GE Nuclear Energy

April 16, 1996

MFN 050-96
Docket No. 52-001

ABWR Design Change Assessment Review of FOAKE Design Changes

FIGURE 9A 4-11 CONTROL BUILDING FIRE PROTECTION, SECTION B-B
ABWR DCD/Tier 2 .rev. 0 21-565

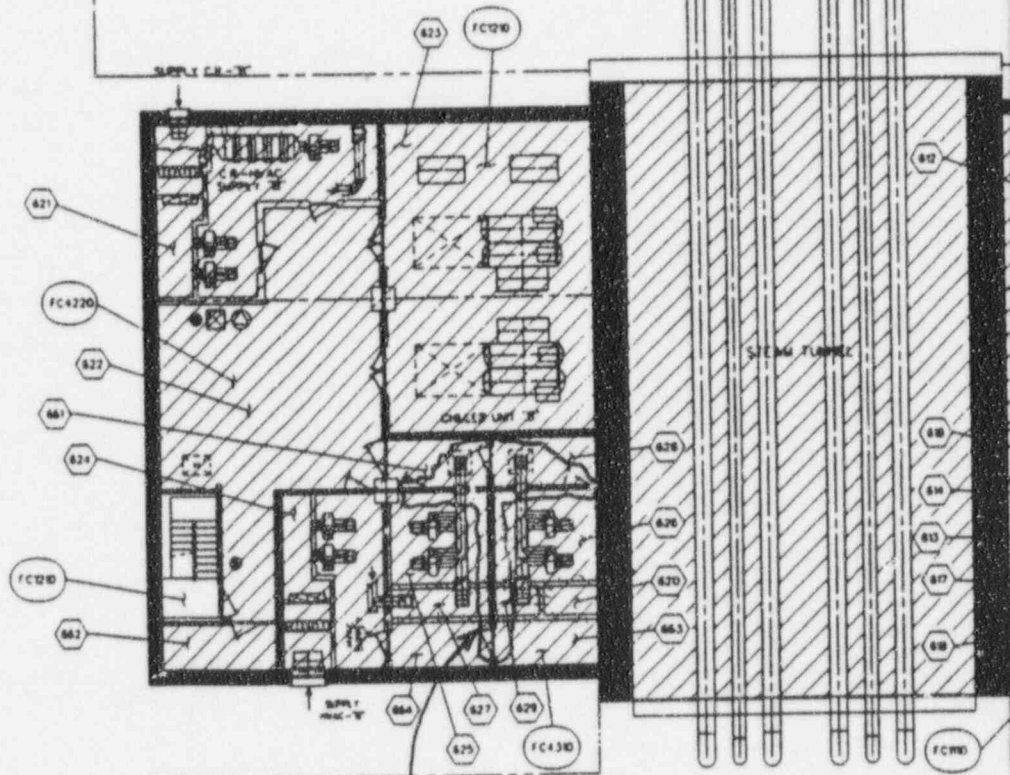
REMOVE FIRE
REACTOR BUILDING

Figure 2.15.5a Control Room Habitability Area HVAC System

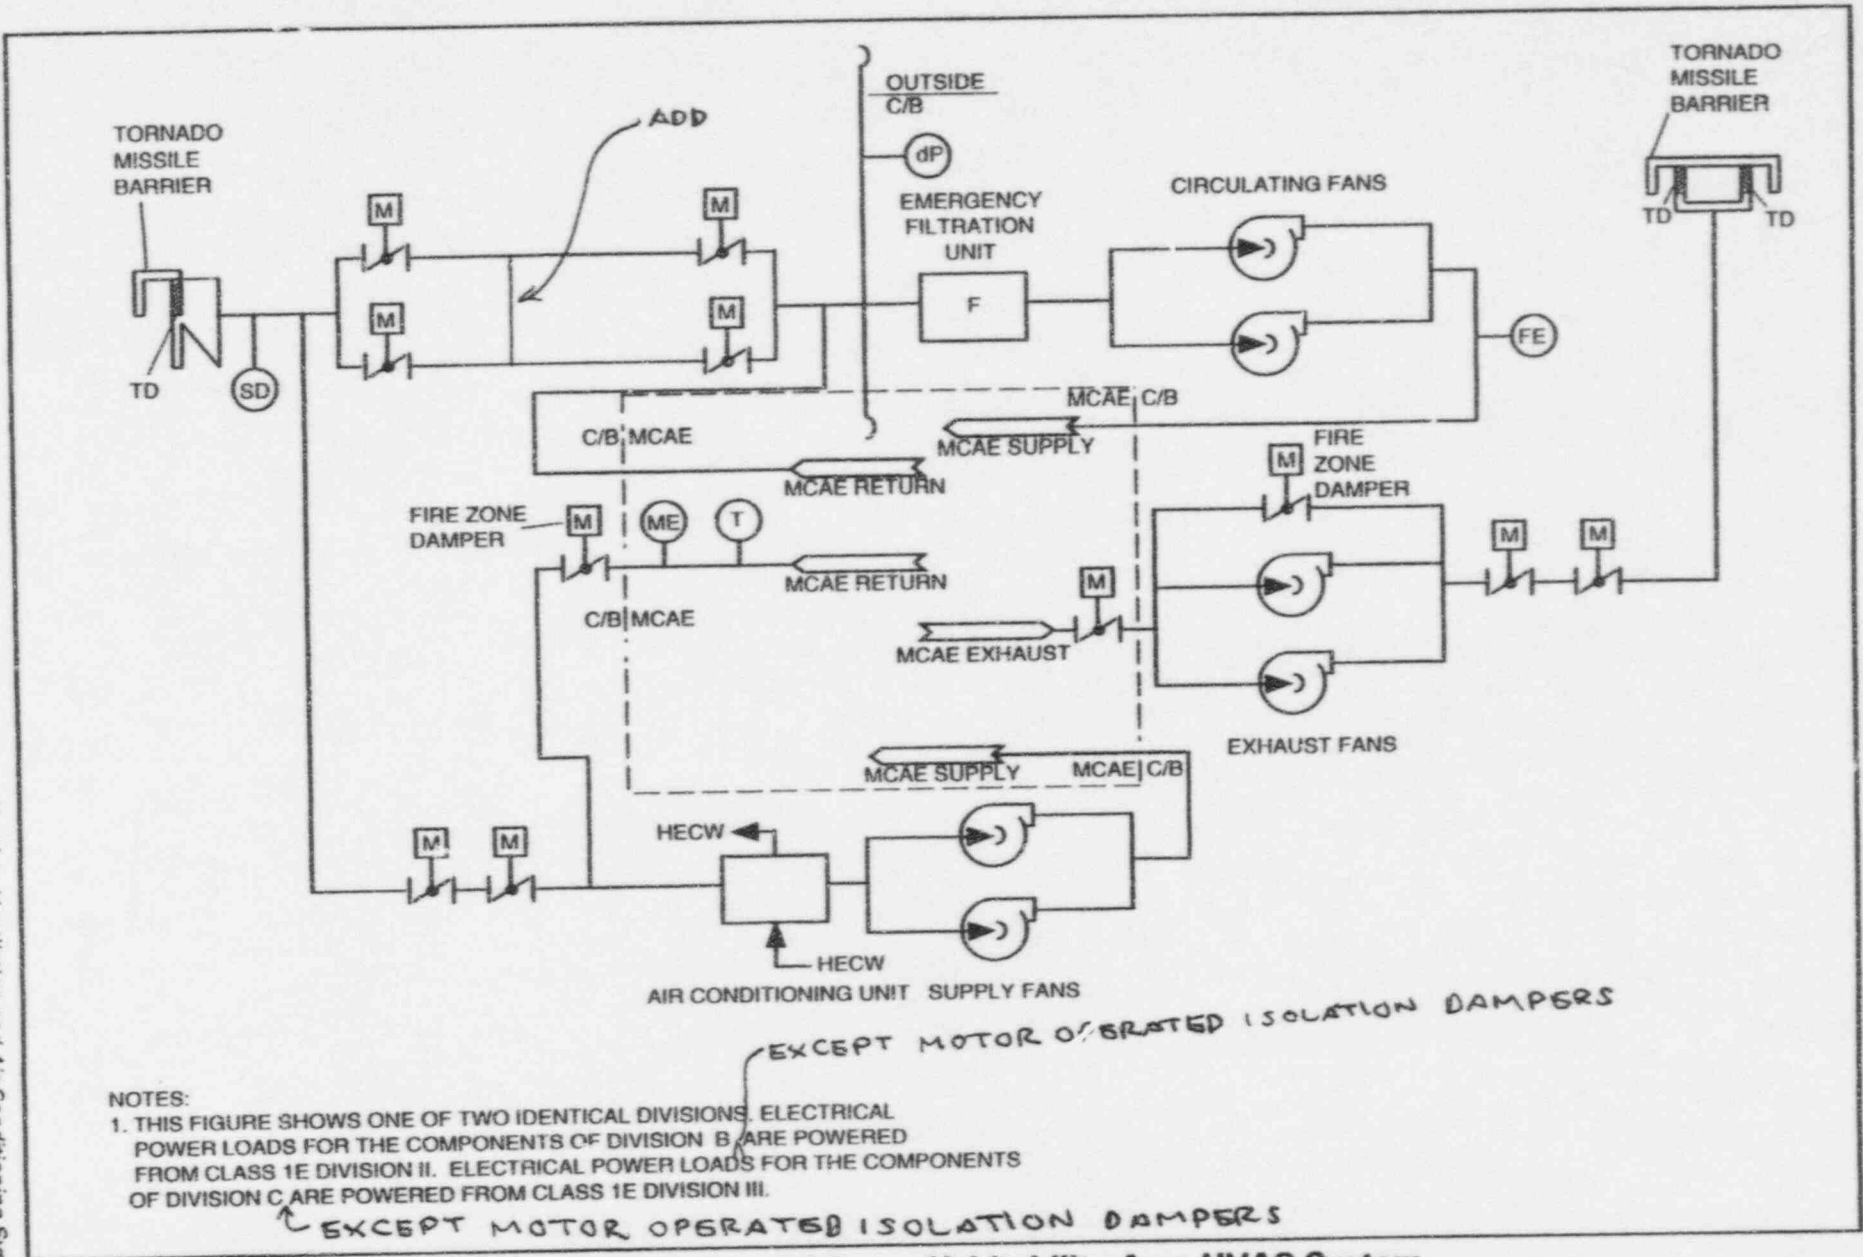
Each of the two CRHA HVAC System divisions, with the exception of the motor operated isolation dampers, is powered from the respective Class 1E division as shown on Figure 2.15.5a. Each pair of motor operated isolation dampers in series is powered from two independent Class 1E divisions (one damper is powered from Class 1E division II and the other damper is from Class 1E division III). In the CRHA HVAC System, independence is provided between Class 1E divisions, and also between the Class 1E divisions and non-Class 1E equipment.

2. EACH PAIR OF MOTOR OPERATED ISOLATION DAMPERS HAS ONE DAMPER POWERED FROM CLASS 1E DIVISION II AND THE OTHER DAMPER FROM CLASS 1E DIVISION III

FIGURE 9.4-1 CONTROL BUILDING HVAC FLOW DIAGRAM (Sheet 2 of 5)

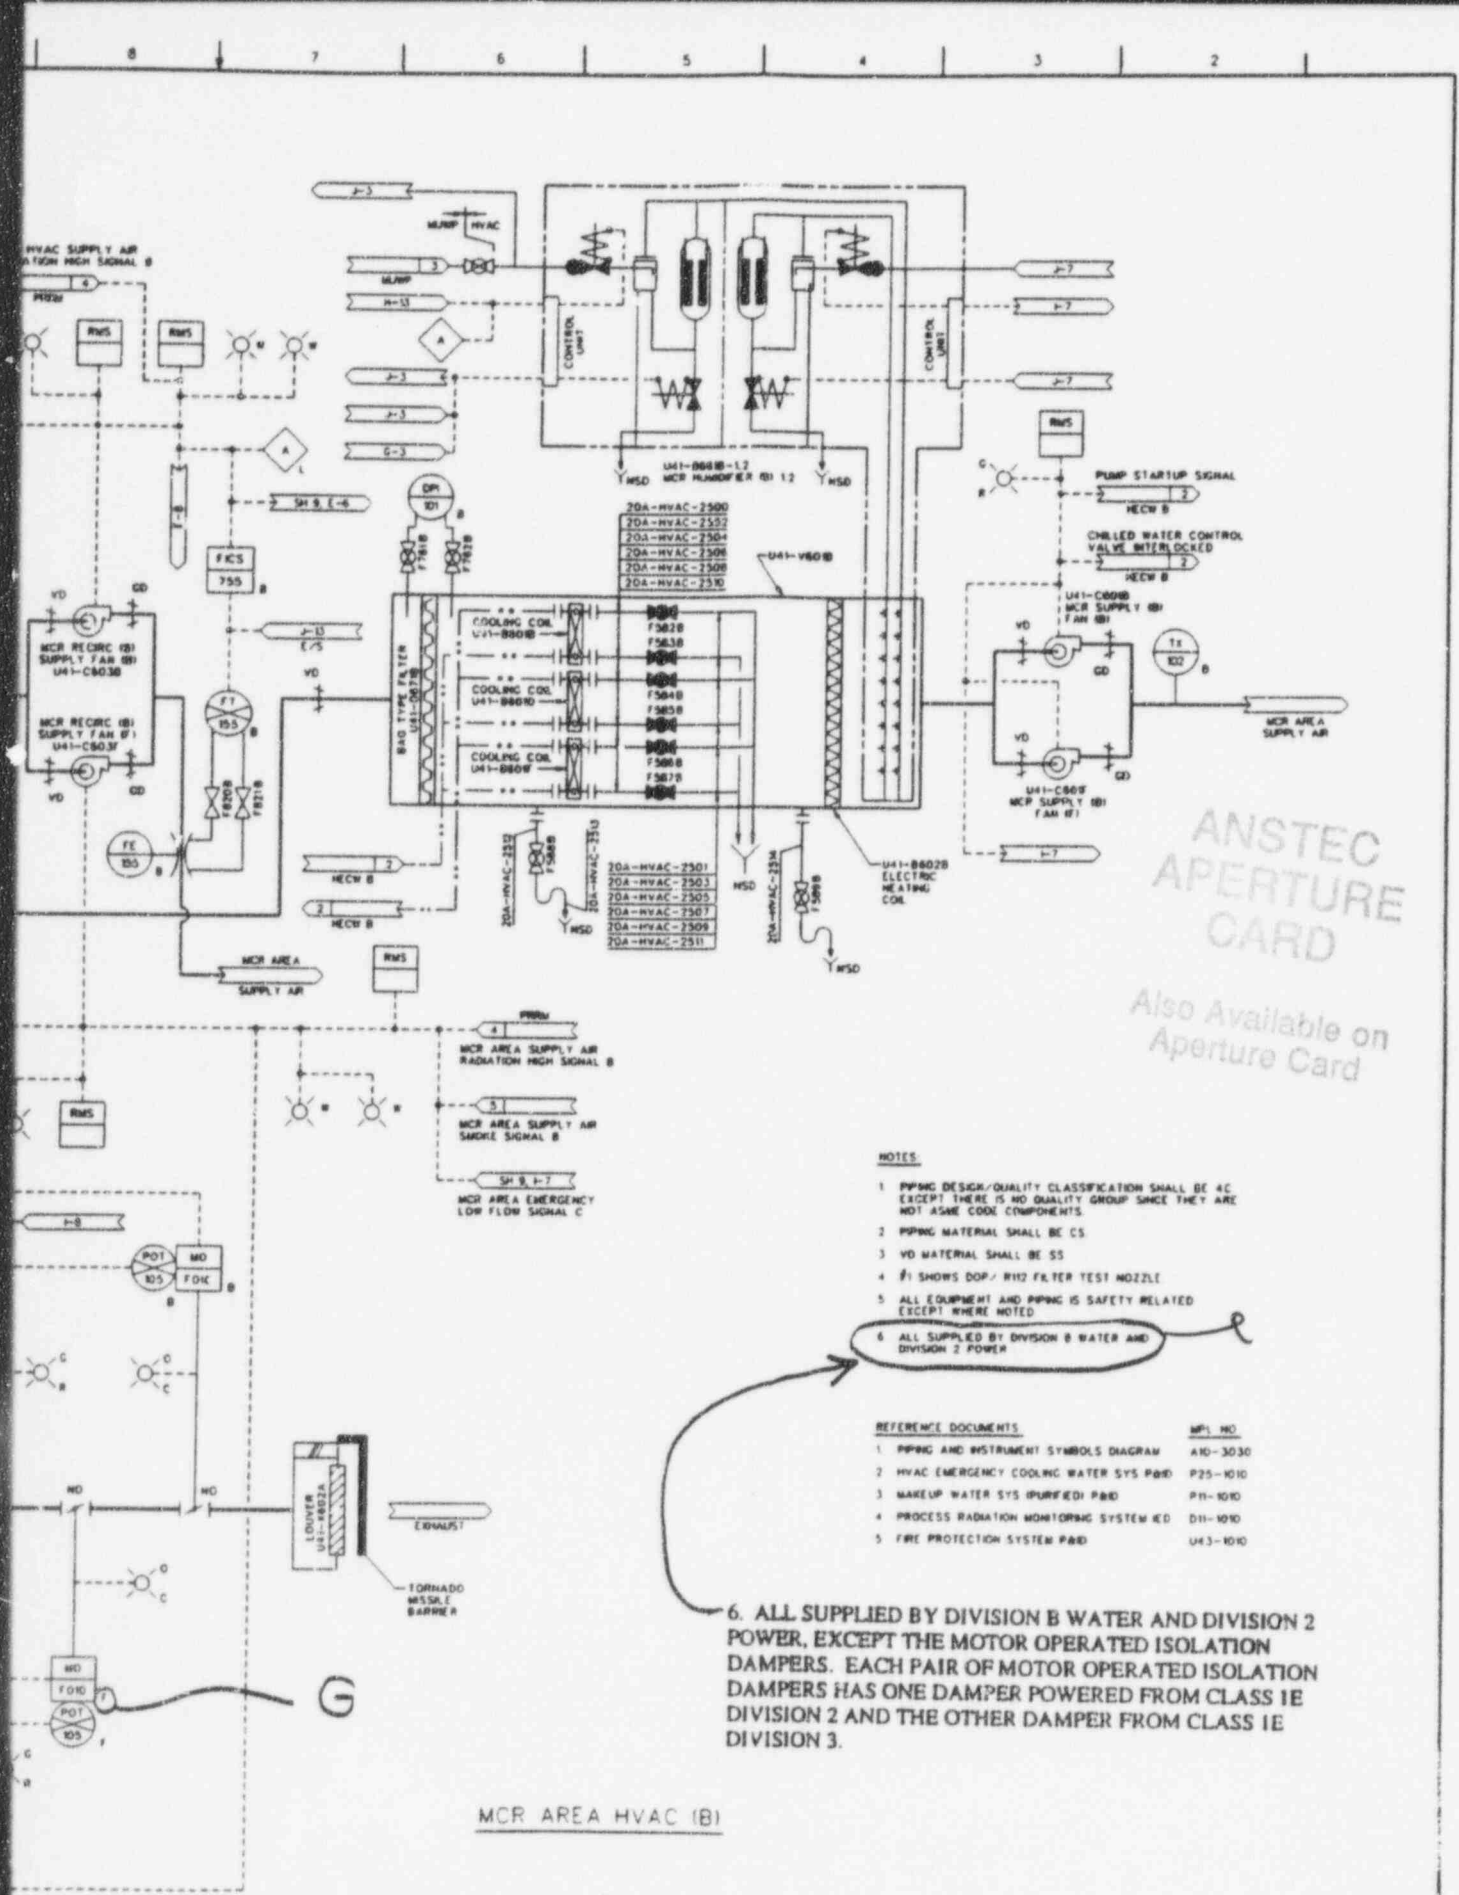
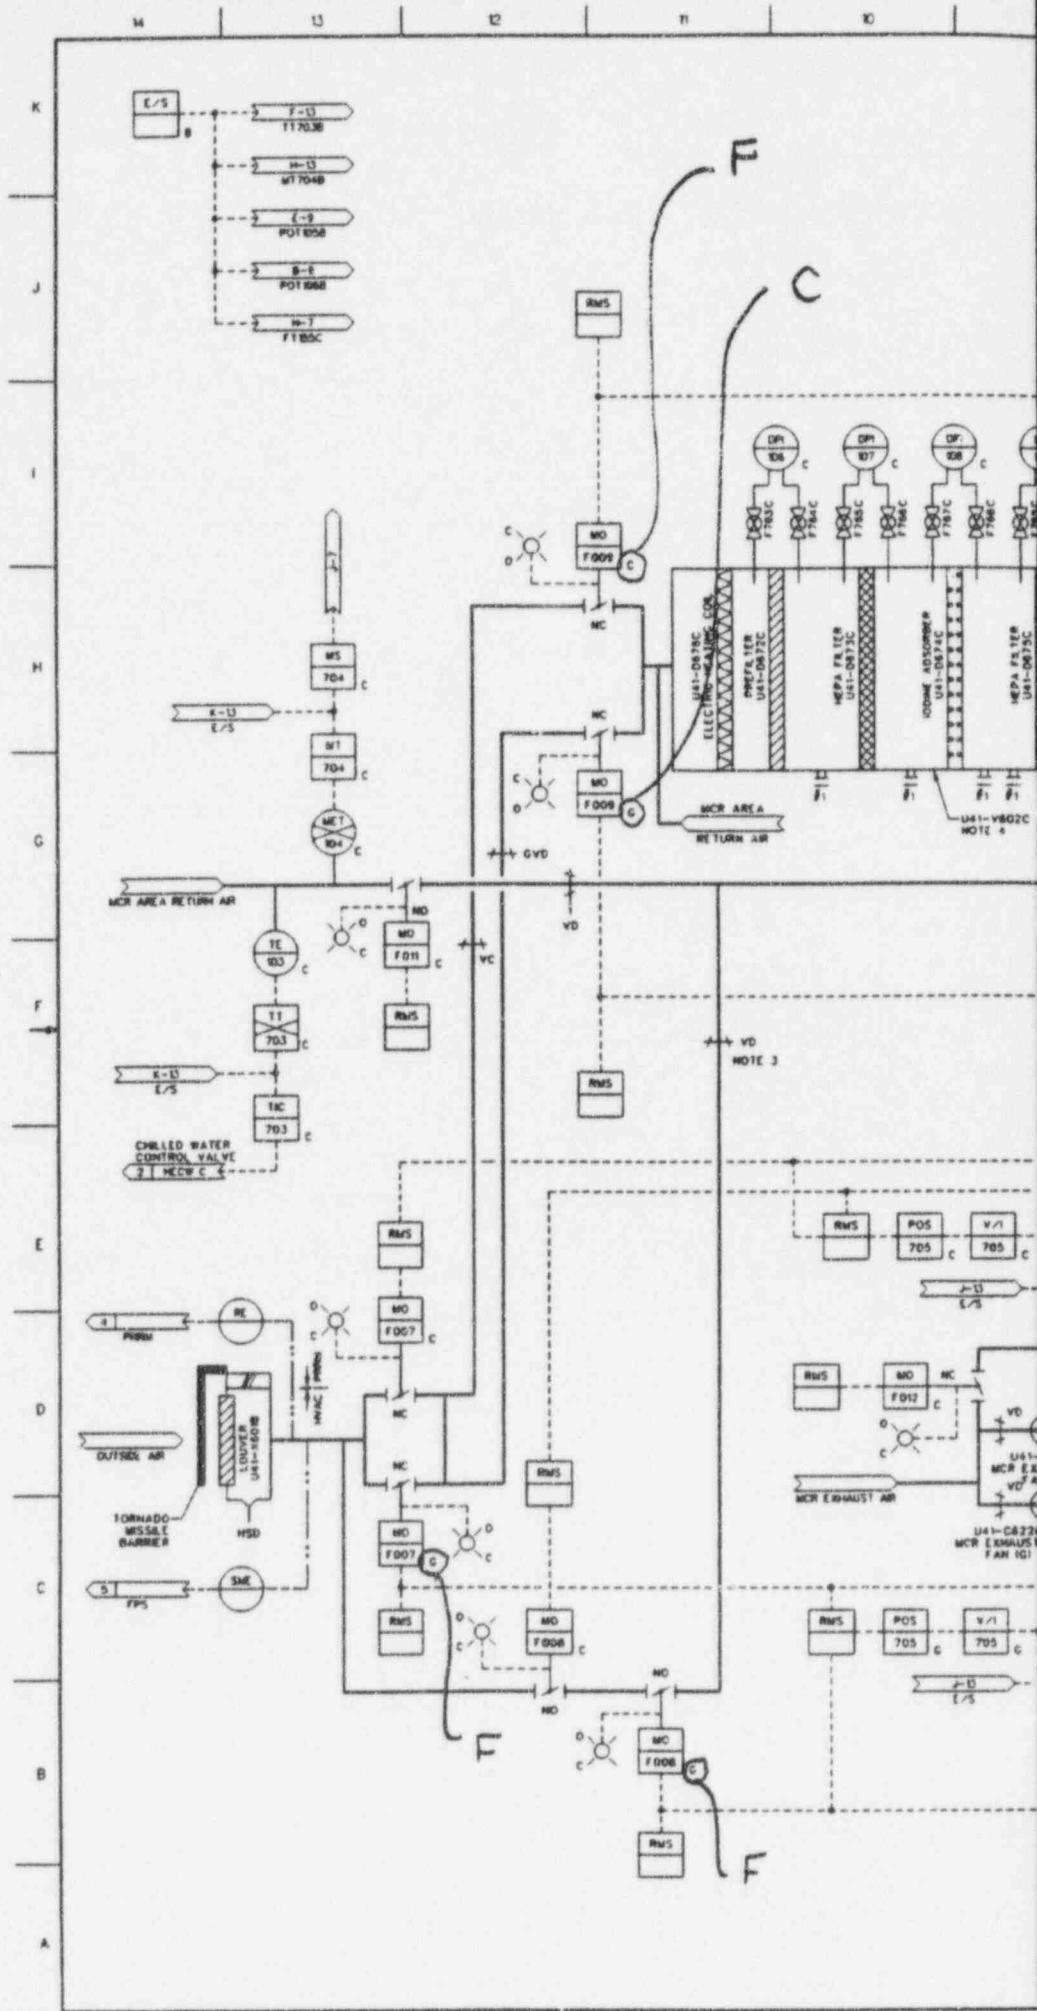
← ADD

FIGURE 5.4-B REACTOR CORE ISOLATION COOLING SYSTEM P&ID (Sheet 3 of 3)
 ABWR DCD/Tier 2 Rev. 0 21-100

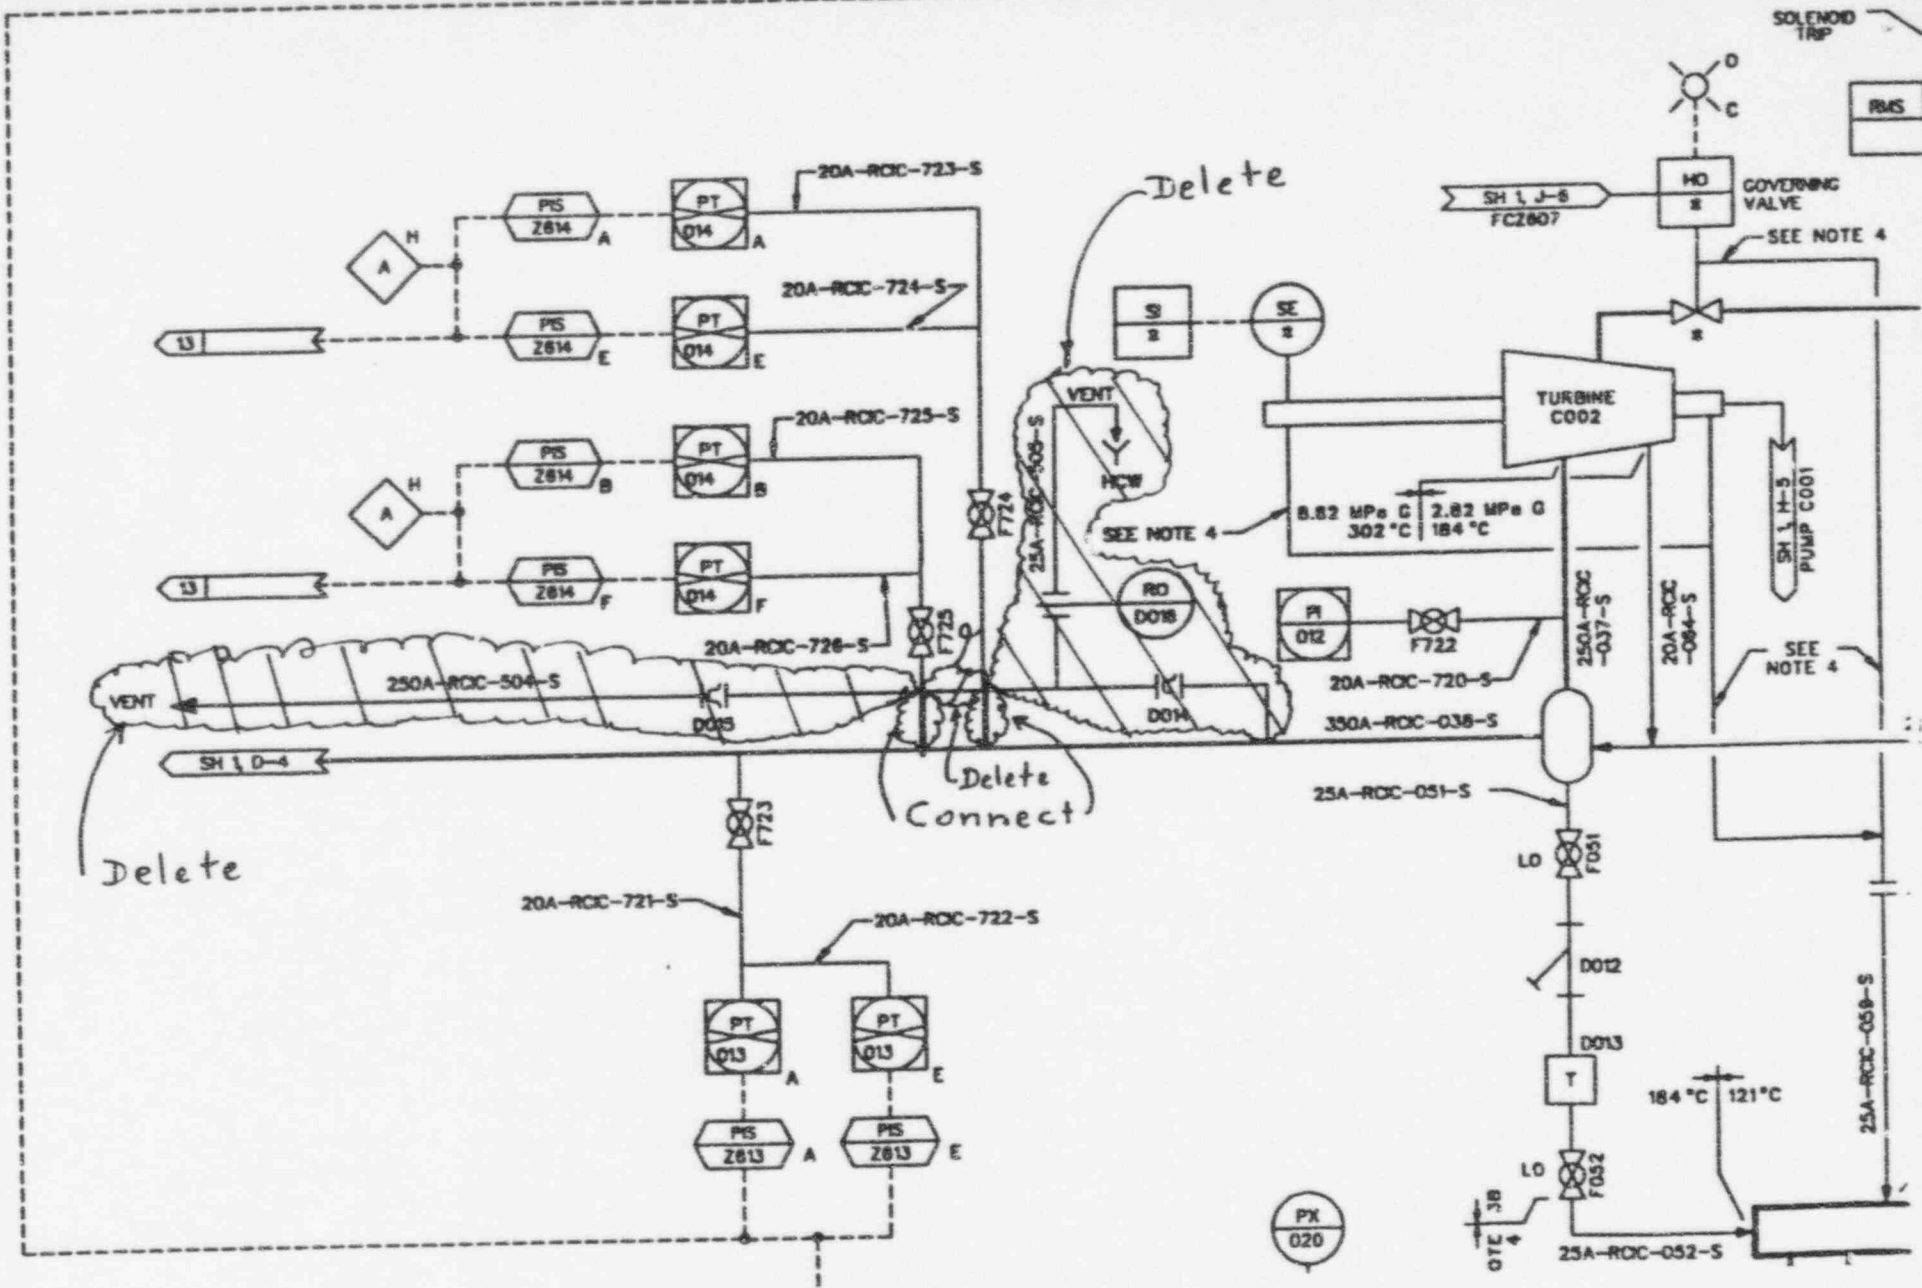
Reference	Components	Press./Temp./Design/ Seismic Class	Remarks
Sheet 3	250A-RCIC-037-S Pipe	2.82 MPaG, 184°C,3B,As	Was 0.981 MPaG
	20A-RCIC-720-S Pipe	2.82 MPaG, 184°C,3B,As	Was 0.981 MPaG
	20A-RCIC-F722 Valve	2.82 MPaG, 184°C,3B,As	Was 0.981 MPaG
	20A-RCIC-PI012 P.Ind.	2.82 MPaG, 184°C,3B,As	Was 0.981 MPaG

Sheet 1	350A-RCIC-F038 Check	2.82 MPaG, 77°C, 3B, As	Was 1.37 MPaG
	20A-RCIC-053-S Pipe	2.82 MPaG, 184°C, 3B, As	Was 0.981 MPaG
	20A-RCIC-F053 T.Valve	2.82 MPaG, 184°C, 3B, As	Was 0.981 MPaG
	350A-RCIC-F039 Valve	2.82 MPaG, 184°C, 3B, As	Was 0.981 MPaG
	A-RCIC-F069 T.Valve	2.82 MPaG, 184°C, 3B, As	Was 10.981 MPaG

Replace all four with "8.62"

Replace all four with "302"

Replace all ten with "8.62"

Replace all ten with "302"

Replace all four with "8.62"

Replace all four with "302"
